Product/Process
Change
Notification
PCN07053

Product:	HPL 507	Part Numbers Concerned:	See list attached
Product Manager:	Alan Chen	Issue Date:	27 March, 2007
		Page(s):	2
Distribution:	GLOBAL

Soldering type DDR II and FBDIMM housing enhancement

Standoff closer view(No Rib) – current

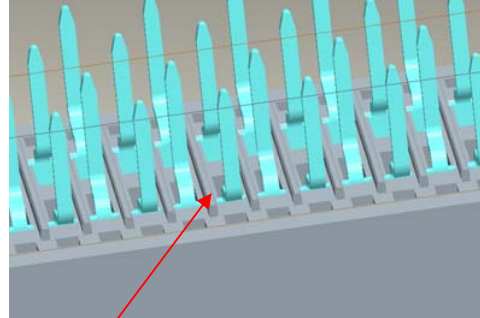
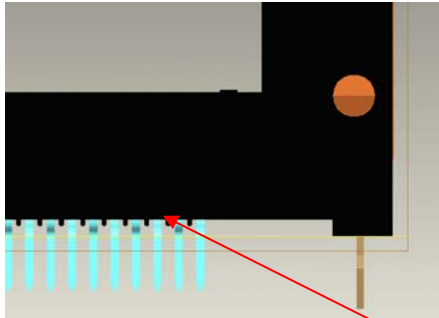
As part of the continuous improvement, FCI is making a change to all Vertical Soldering Type DDR II and FBDIMM housing by adding a rib on the bottom of housing. The connector with this change will be more robust from the housing damage and avoid tin crossing in wave soldering process.

FCI will enhance the housing standoff by adding the rib; refer to the drawing below for detail. After the change the connector will be more robust from the housing damage and avoid tin crossing. There will be a minor change on the outside appearance and no impact to fit & function and customer application as well.

Standard off closer view – new(With Rib)

RIB
